Re: GI2015-04-SCE70-02A-05-07-09
Southern California Edison Response to CPUC General Order (G.O.) 112-E¹
Operation and Maintenance Inspection of Southern California Edison Company's
Liquid Petroleum Gas (LPG) distribution system in the City of Avalon, CA

Inspection Report and SCE Response

CPUC 2015 Inspection of SCE Catalina Gas System

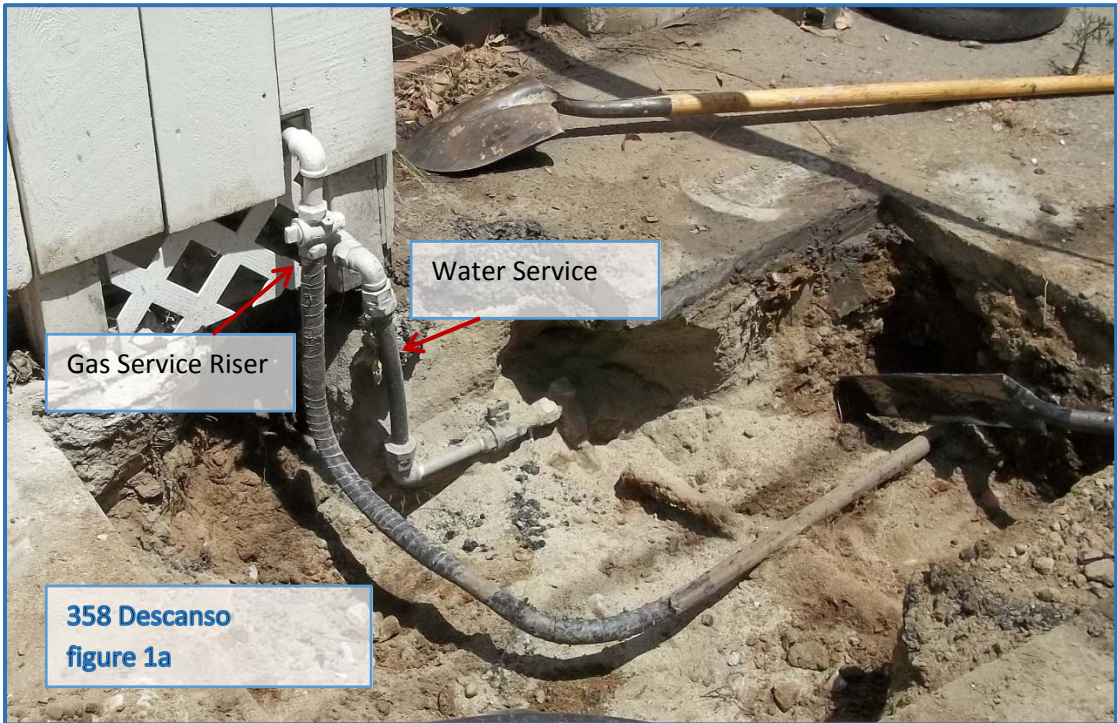
SED staff observed during the field inspection of SCE's facilities that SCE's customer meters, regulators, and aboveground facilities were exposed to vehicular traffic at the following locations:

- 1) 358 Descanso Ave. Avalon
- 2) 340 Descanso Ave. Avalon
- 3) Near valve #5 (3 MSAs)
- 4) 411 Crescent Ave., Avalon (El Galleon Restaurant)
- 5) Lower Olive Street, Avalon (riser exposed to vehicular traffic)
- 6) 800 Crescent Ave., Avalon
- 7) 413 Crescent Ave, Avalon

SCE failed to identify and protect the customer meters, regulators, and aboveground facilities at the aforementioned locations from vehicular traffic damage. Therefore, SCE is in violation of G.O. 112¹, Reference Title 49, Code of Federal Regulations (49 CFR), Part 192, Section 192.353(a).

Item 1: *358 Descanso Ave*, the riser has been relocated to eliminate exposure to intermittent and occasional traffic found in this area. Adjustment was completed on or before 07/30/2015. See figure (1a) and figure (1b).

Item 2: *340 Descanso Ave*, the riser has been relocated to eliminate exposure to intermittent and occasional traffic found in this area. Adjustment was completed on or before 07/30/2015. See figure (2a) and figure (2b).

Item 3: *The 3 MSAs Near Valve #5*, a new bollard has been installed to minimize the possibility of vehicular damage. As mentioned above, this location is shared with item (6) below. Adjustment was completed on or before 07/30/2015. See figure (3).

Item 4: *411 Crescent (El Galleon Restaurant)*, a new bollard has been installed to minimize the possibility of vehicular damage. This location is shared with item 7. Adjustment was completed on or before 08/07/2015. See figure (4).

Item 5: *Lower Olive Street (exposed risers)*, the existing bollards were raised with the height increased to minimize the possibility of vehicular damage. Additional atmospheric corrosion protection and labeling added. Adjustments were completed on or before 07/30/2015. See figures (5A), (5B), (5C), (5D) and figure (5E).

Item 6: *800 Crescent Ave.*, two new bollards have been installed to minimize the possibility of vehicular damage. As mentioned previously, this location is shared with item (3) above. Adjustment was completed on or before 07/30/2015. See figure (3).

Item 7: *413 Crescent*, a new bollard has been installed to minimize the possibility of vehicular damage. This location is shared with item 4. Adjustment was completed on or before 08/07/2015. See figure (4).
